Value Engineering Study  
**US60 RECONSTRUCTION**  
BALLARD & MCCrackEN COUNTY, KY

ITEM NUMBER 1-115.00 & 1-115.10  
VE STUDY NUMBER 201109

**VALUE ENGINEERING STUDY  
for  
Kentucky Transportation Cabinet  
Frankfort, Kentucky**

**Draft Report**

### Typical Section for Mainline US 60

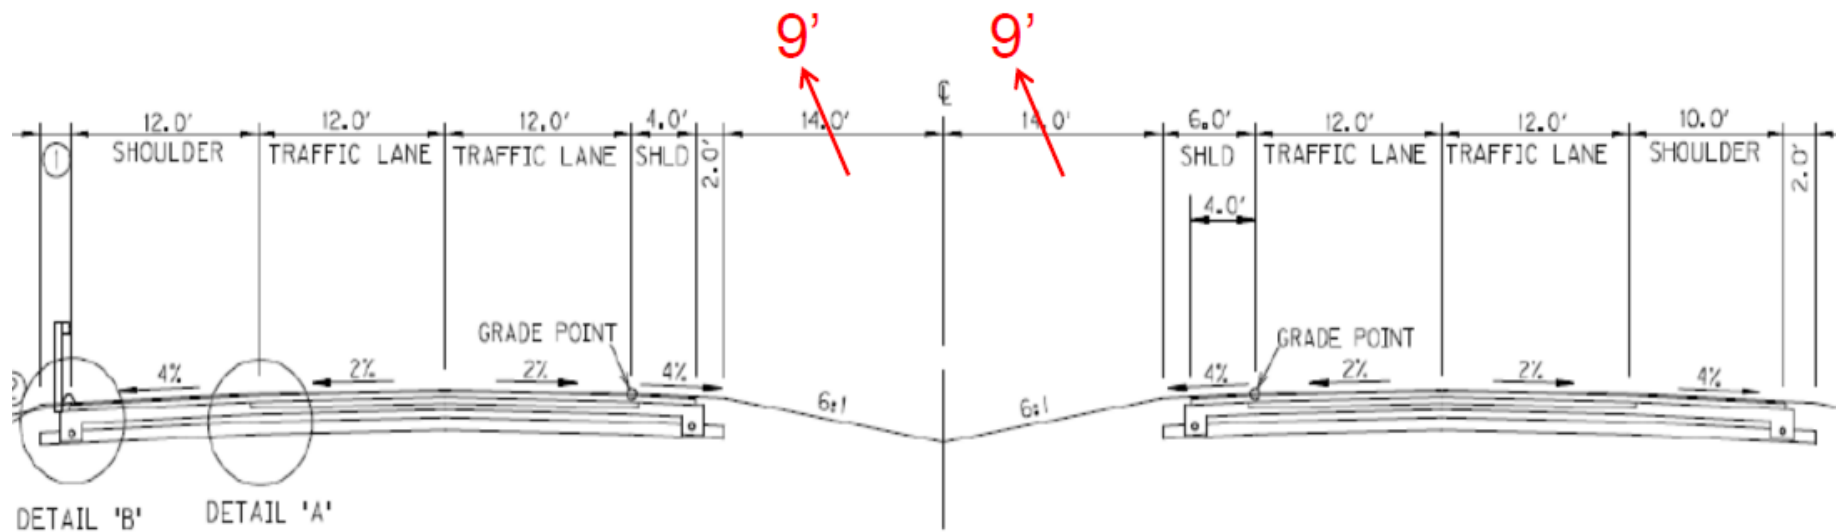
Utilize a 30 ft depressed grass median in lieu of a 40 ft depressed grass median.

The VE Team recommends reducing depressed median section from 40 ft wide to 30 ft wide throughout mainline section. This 10 ft reduction in template width will decrease the earthwork volumes, right of way footprint and shorten the drainage structures.

### Typical Section for Mainline US 60

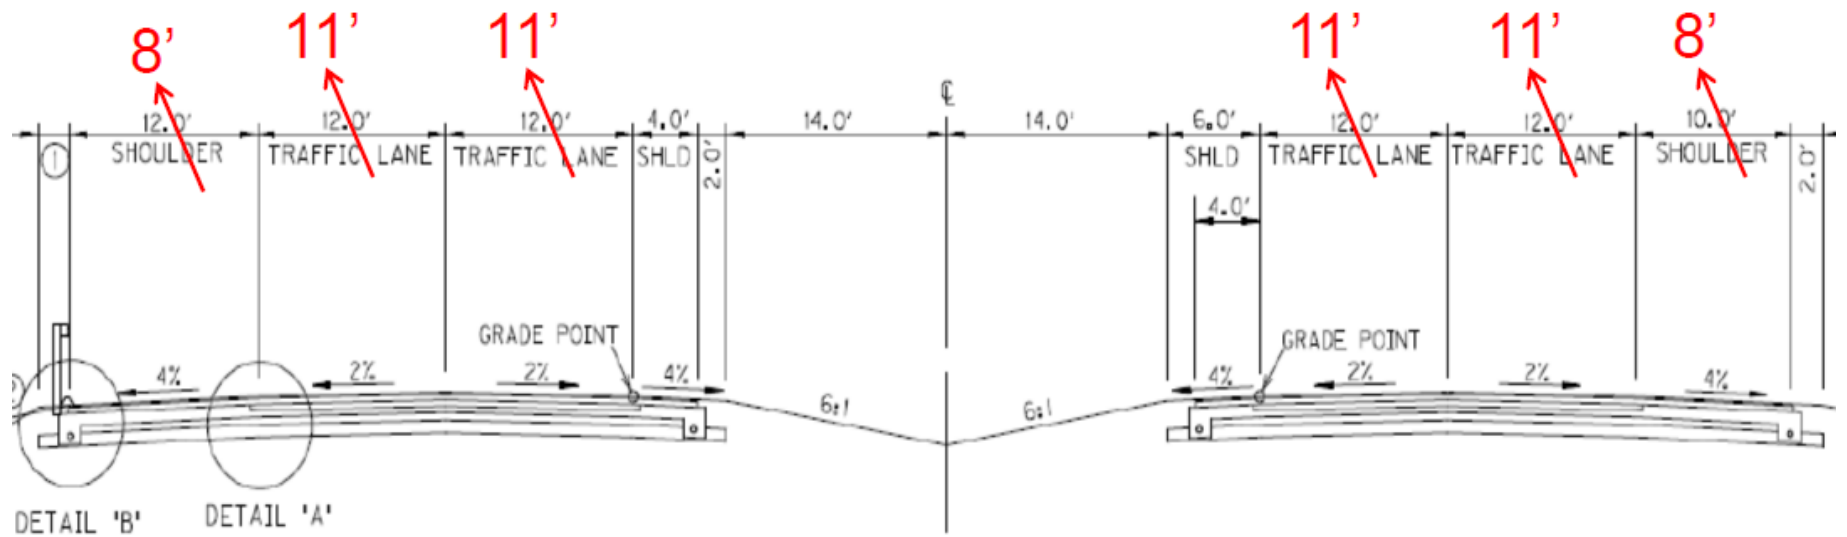
Utilize 11 ft traffic lanes and 8 ft paved outside shoulders in lieu of 12 ft traffic lanes and 10 ft paved outside shoulders.

The VE Team recommends utilizing an 11 ft traffic lane versus a 12 ft traffic lane as studies have shown that there is not an appreciable change in operation or safety by reducing the lane width from 12 ft to 11 ft. Similarly, the VE Team recommends utilizing an 8 ft paved outside shoulder width versus a 10 ft paved outside shoulder as it complies with the AASHTO and KYTC Highway Design Manual.

**US60 Typical Section (EB Section Shown)**

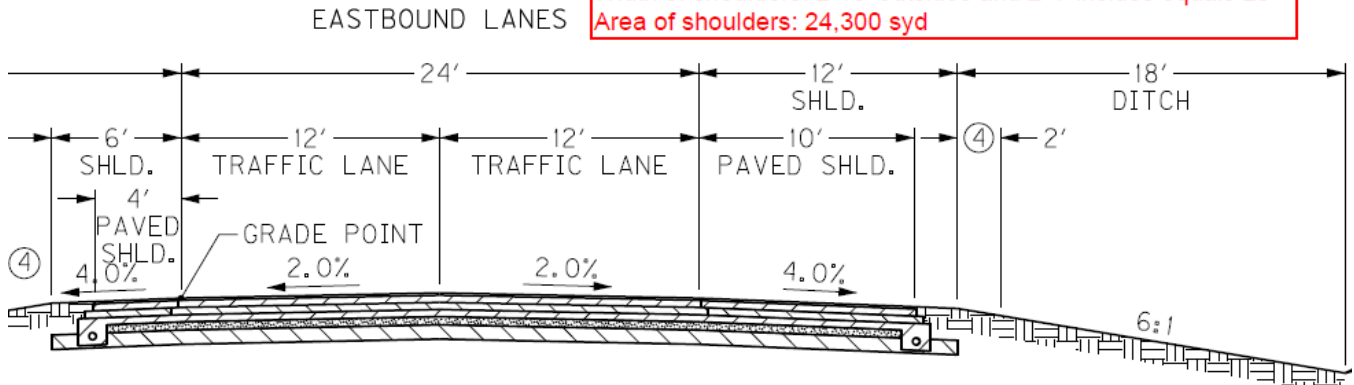
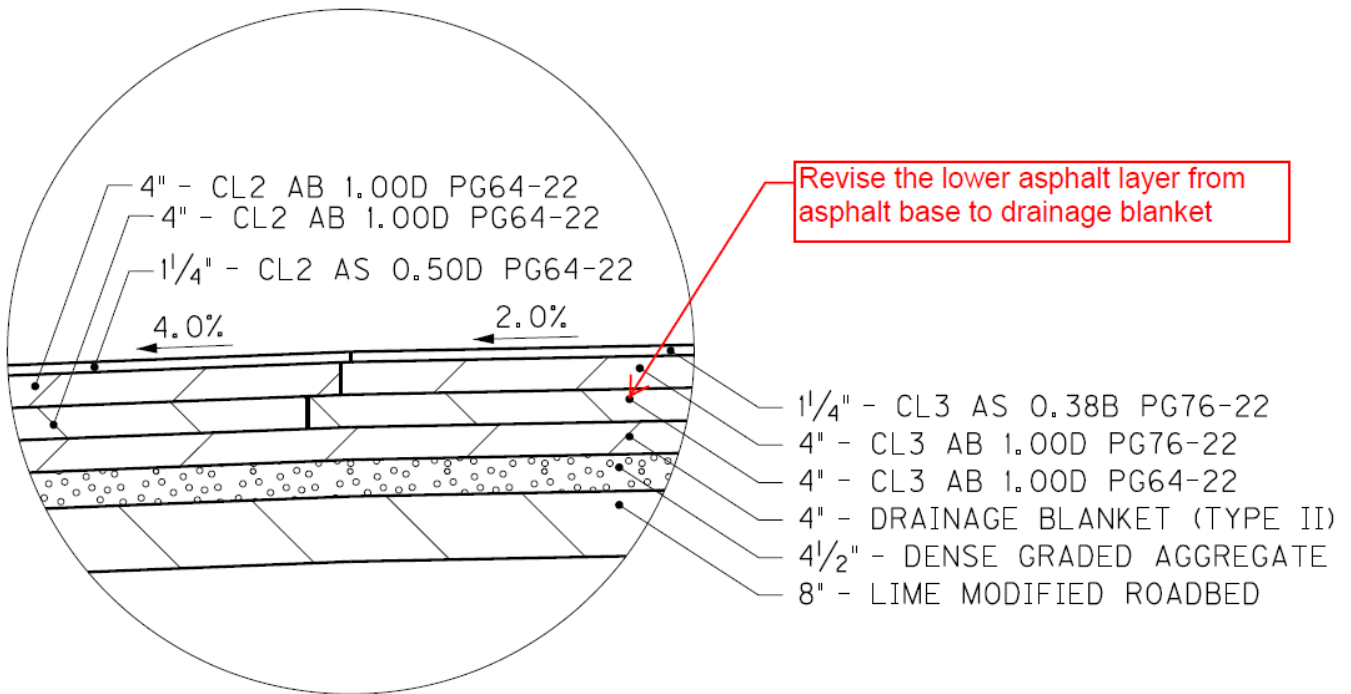
Reduce shoulder asphalt section in lieu of full depth shoulders.

The original design specifies asphalt shoulders that have the same depth as the asphalt mainline. This design is reflected in the graphics below. The total asphalt depth of 9.25 inches is comprised of 1.25 inches asphalt surface with CI 2 PG 64-22 in the shoulders and CI 3 PG76-22 in the mainline, 4 inches of asphalt base with CI 2 PG64-22 in the shoulders and CI 3 PG76-22 in the mainline, and 4 inches of asphalt base with CI 2 or CI 3 PG64-22 in the shoulders and mainline.

The VE Team recommends replacing the lower 4 inches of asphalt base in the shoulders with Drainage Blanket (Type II). The graphic above provides a detail for this change and the graphic below provides an example of the depth transition between shoulder and mainline.

Example of HMA Depth Transition Between Shoulder and Mainline

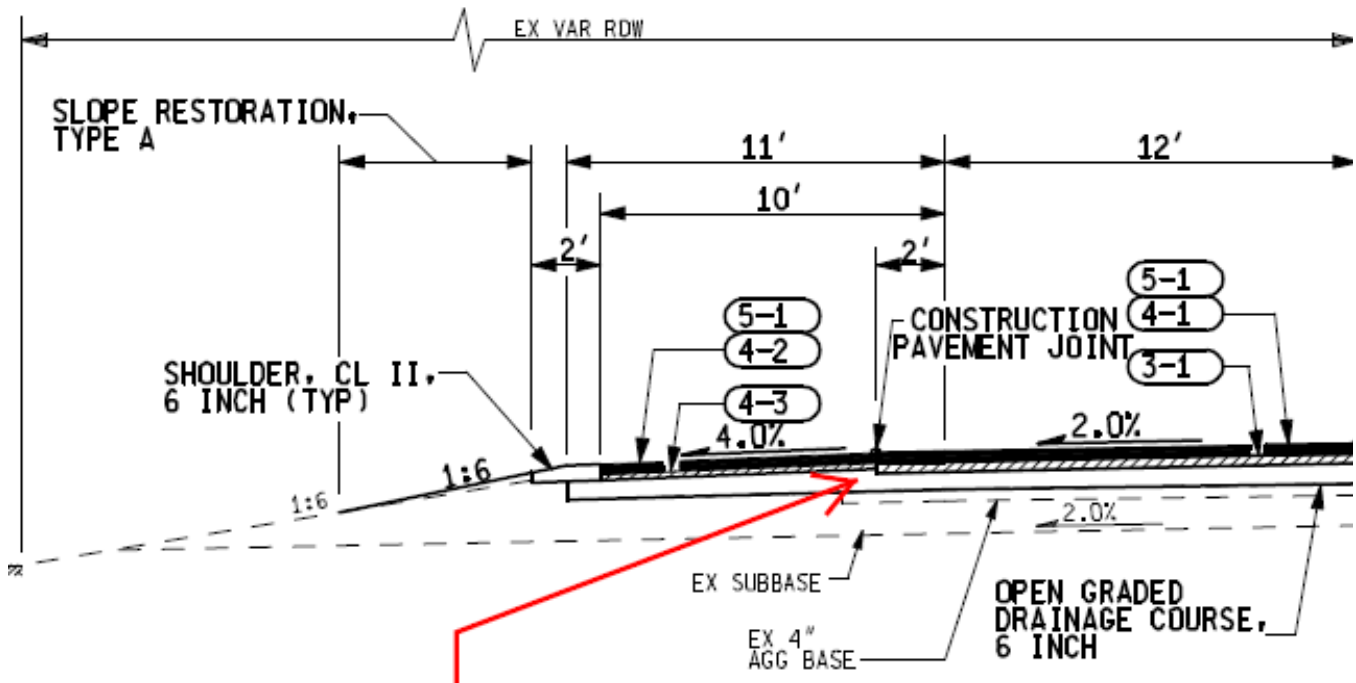
HMA depth transitions from 5.5" in shoulder to 7" in mainline

**Item No 115.00 Typical Section Applied to Asphalt Approaches**

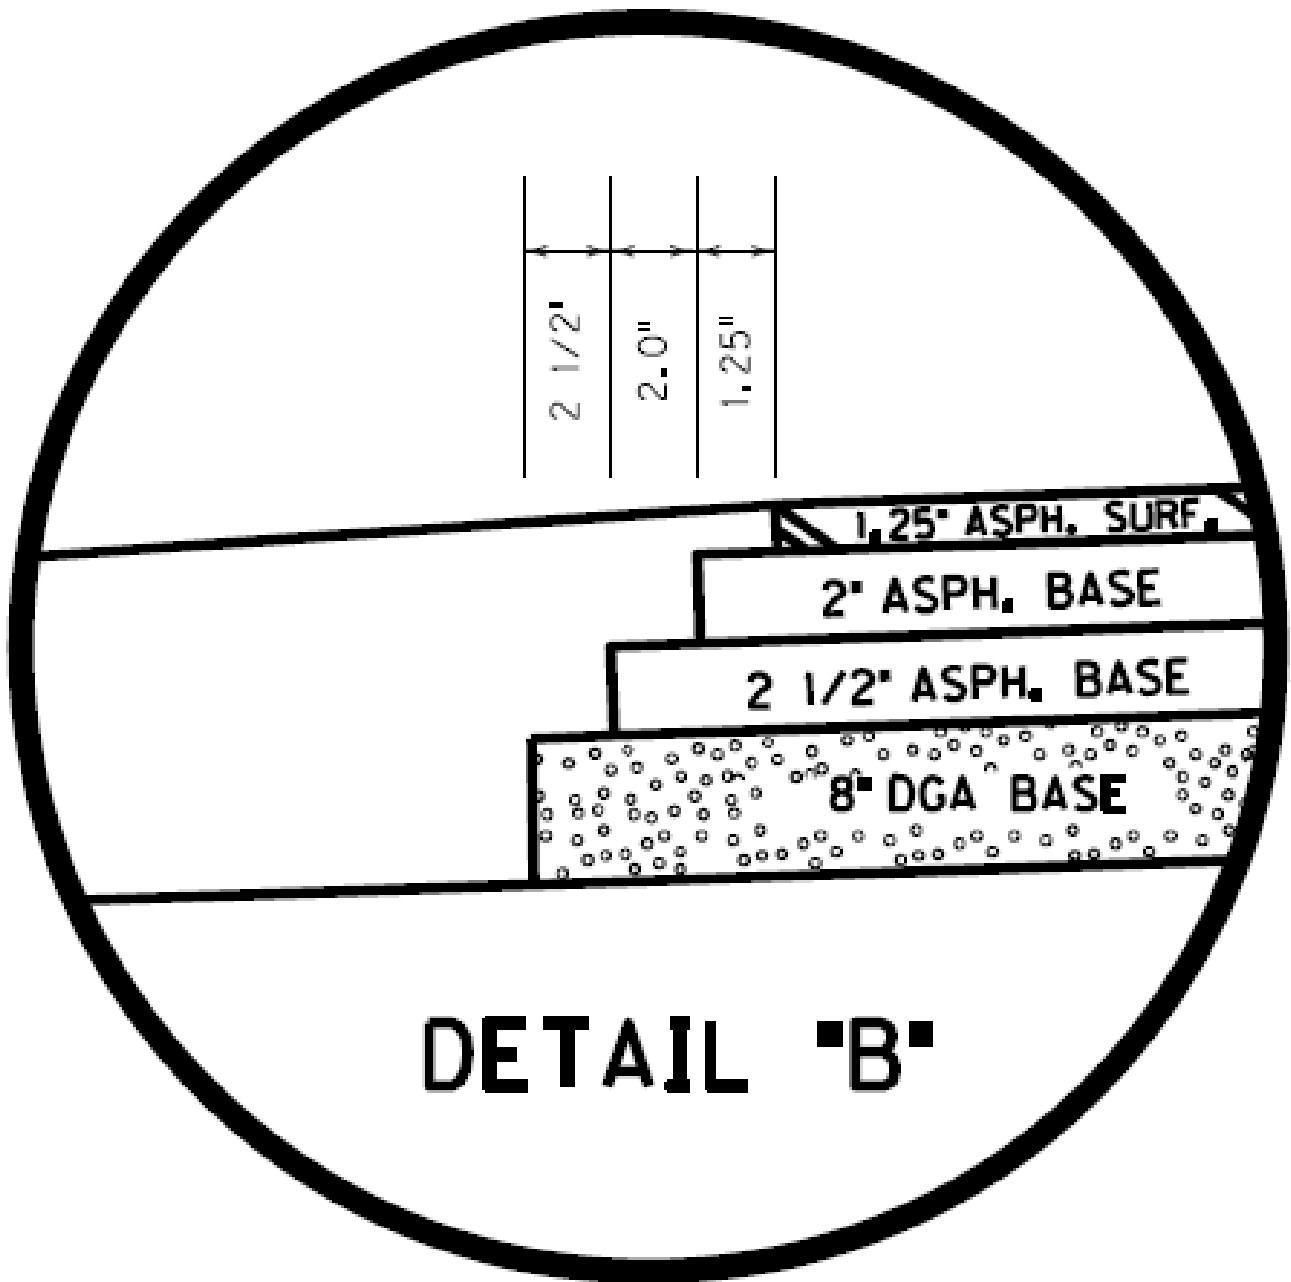
Where intersecting roads are to be reconstructed, reduce the asphalt section from 9.25 inches to 5.75 inches where applicable.

The original design specifies asphalt approaches that have the same depth as the asphalt mainline. This design is reflected in the graphics below. The total asphalt depth of 9.25 inches is comprised of 1.25 inches asphalt surface with CI 2 PG 64-22 in the shoulders and CI 3 PG76-22 in the approach lanes, 4 inches of asphalt base with CI 2 PG64-22 in the shoulders and CI 3 PG76-22 in the approach lanes, and 4 inches of asphalt base with CI 2 or CI 3 PG64-22 in the shoulders and approach lanes.

The VE Team recommends an asphalt approach design that is appropriate for the low traffic volumes on the approach roads and drives. The asphalt approach design that is recommended is shown below. This asphalt approach design is taken from the item number 115.10 plans and already applies to a number of the approaches on that project.

**Sketch of Original Design Vertical Curves at Westerly End of Item No. 115.00**

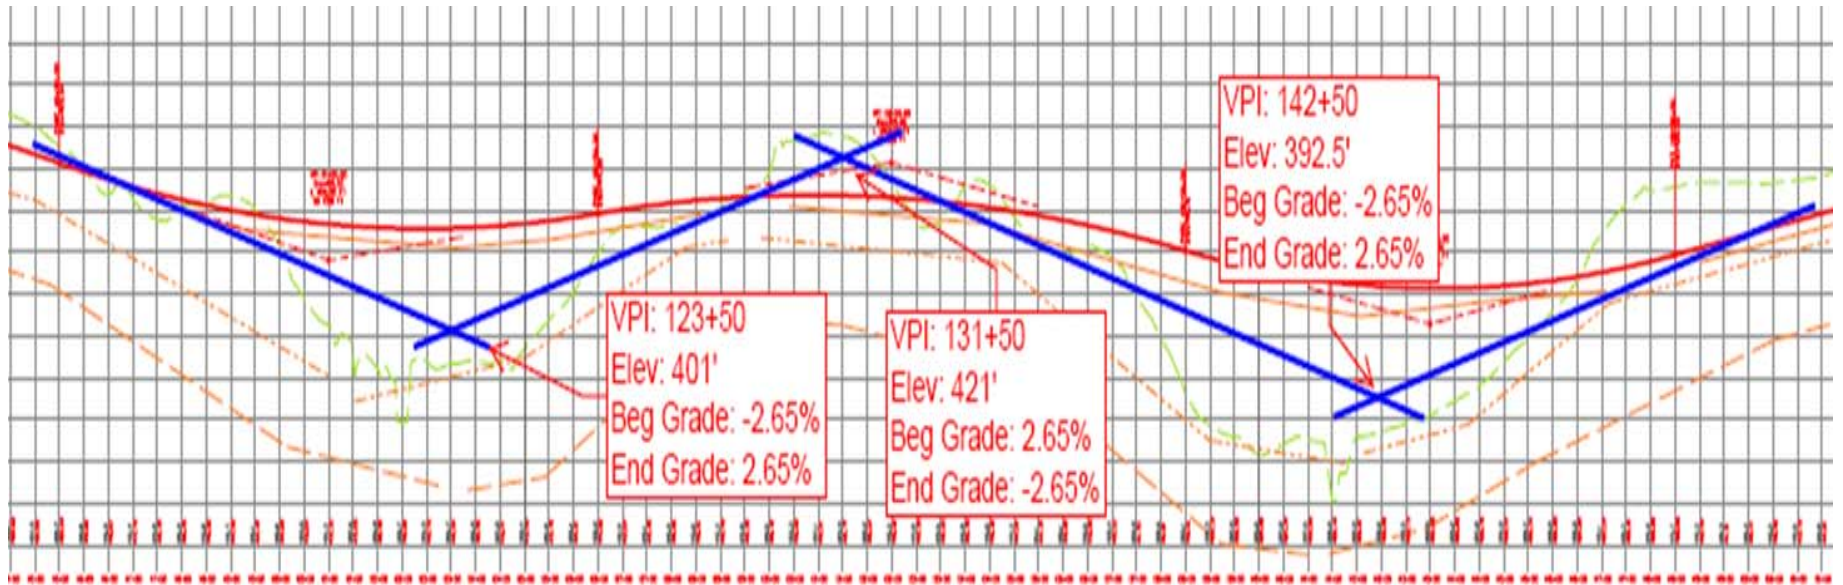
The VE Team recommends using maximum allowable grade and minimum allowable sight distance to reduce the embankment depth at the locations listed above. The maximum allowable grade of 2.65% is identified in the Item Number 115.00 Design Executive Summary shown in the figure below. The minimum allowable sight distance of 570 ft (K=151) is shown in Exhibit 3-76 of the AASHTO-Geometric Design of Highways and Streets that is included below.

The embankment depths were reduced by using the maximum grade of 2.65% and the minimum allowable sight distance of 570 ft. An example road profile revision is shown in the attached drawing, vertical curve tables, and road elevation comparison table. These vertical curve and road elevation revisions were roughly applied to item number 115.00 Stations 117 to 150. Another option within these stations that was not explored is to lower the elevation of the hill between the two low areas (and therefore the point of intersection of Sullivan Lane) in order to eliminate the down/up/down profile that is part of the attached example.

Sketch of Old US60 17+00 and US60 122+50 Culvert Modification and Stream Relocation at the West End of 1-115.00

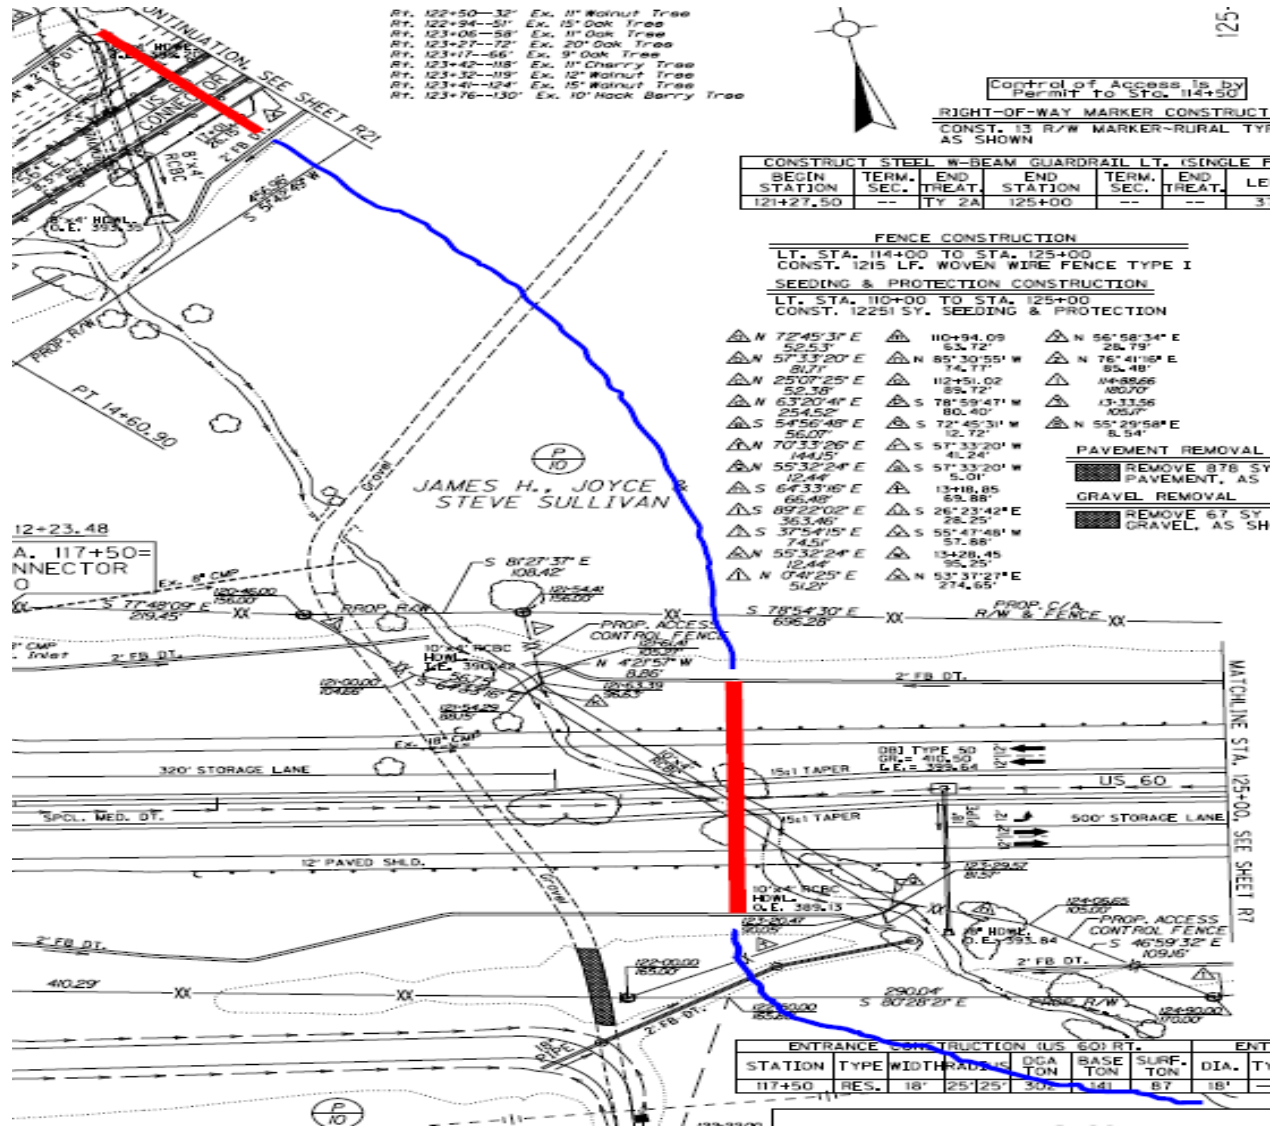
Old US60 Station 17+00 – Revised box culvert location fits from ditch bottom to ditch bottom with 4:1 slopes. This allows for elimination of guardrail as long as the ends of the culvert are outside the clear zone.

US60 Station 122+50 – Revised box culvert location still requires 2:1 slopes and therefore guardrail. If the profile is lowered and the embankment is reduced, the potential exists to use the barn roof section at this location and eliminate guardrail as well.
